SRP and VLAN-IDs
a.k.a. “Comment #26”

Craig Gunther (craig.gunther@harman.com)

14 April 2010

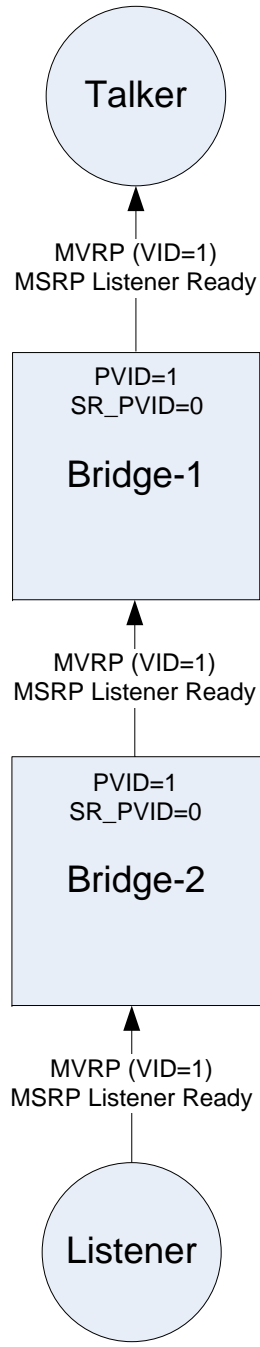
Talker receives MVRP, however it doesn't have to do anything with it.
Talker receives MSRP Listener Ready and can begin Streaming.

(same behavior as Bridge-2)

Bridges receives MVRP and adds port to VLAN Member Set.
Bridge receives MSRP Listener Ready and configures Qav, etc.

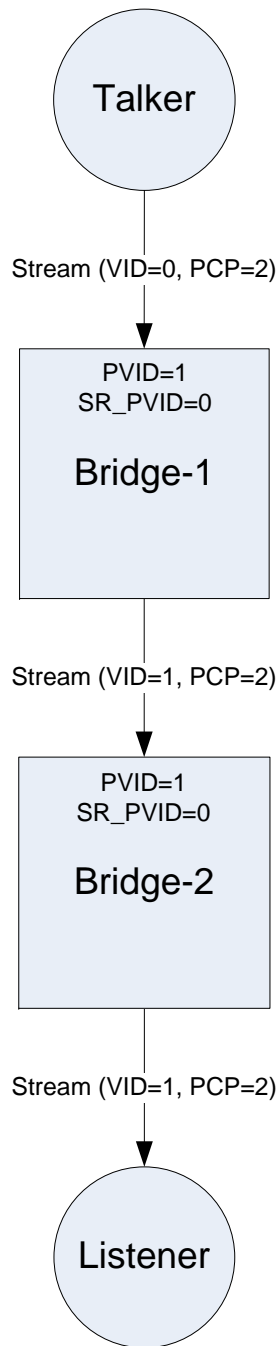
Listener extracts the VID from the Talker Advertise and sends an MVRP ES_REGISTER_VLAN_MEMBER (VID) back to the Bridge.
Listener also sends an MSRP Listener Ready.

Talker begins streaming with VID=0.

Here's a bit of a challenge. The Streaming data comes in with VID=0. How will the Bridge identify this as an MSRP related Stream without a lot of CPU effort? Certainly it could look at the PCP or the MAC DA, then insert the SR_PVID or PVID, but that seems like it may be something unusual to do. If we dismissed the idea of an SR_PVID and just used PVID then the Bridge could do what it already does with the PVID. Maybe the Talker should extract the VID from the MVRP packet, or MSRP could use the SRP Domain packets to tell the Talker which VID to use (This may apply to the Talker Advertise packets as well).

This Bridge routes the Stream data.

Listener receives the Stream data and processes it appropriately.
